STATE OF LOUISIANA  
DEPARTMENT OF PUBLIC SAFETY AND CORRECTIONS  
OFFICE OF STATE FIRE MARSHAL CODE ENFORCEMENT AND BUILDING SAFETY  
8181 INDEPENDENCE BOULEVARD, BATON ROUGE, LA 70806  
800-256-5452 225-925-4920 FAX: 225-925-4414  
WEB SITE: www.dps.state.la.us/sfm

LA FIRE SPRINKLER ASSOCIATION QUARTERLY MEETING  
10-17-2006  
SFM ITEMS OF CONCERN

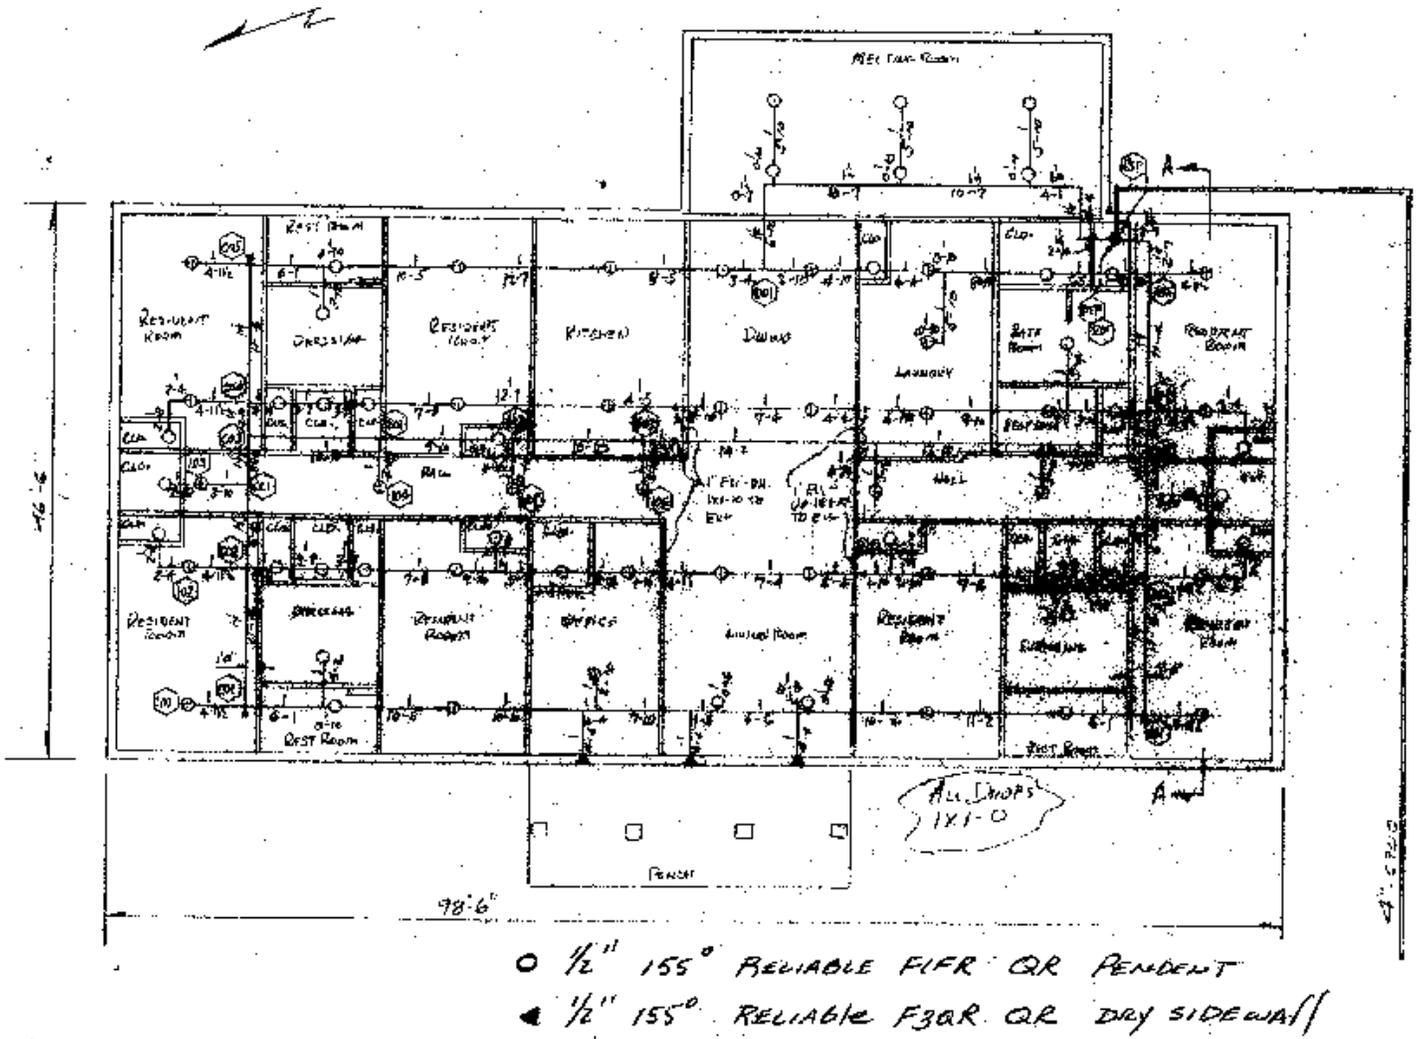
Attached below is a one page copy of a submittal that shows QR sprinklers used throughout a residential board and care, small, with no residential sprinklers. Please tell me if I am evaluating this correctly.

It appears that residential sprinklers are required in the resident rooms and their closets, dressing rooms, and rest rooms while quick response could be used in the halls, office (between resident room and living room) living/dining areas, kitchen, laundry, meeting room and porch, provided that these areas are calculated as areas outside the dwelling unit. Is this correct? Are any areas shown that are required to be protected by quick response sprinklers?

The diagram and description of the dwelling unit when compared with the definition in Section 3.3.4 clearly exceeds 4 sprinklers. Based upon your example, the reference to Section 6.6.7.1.3 would not apply and residential sprinklers would be required throughout.
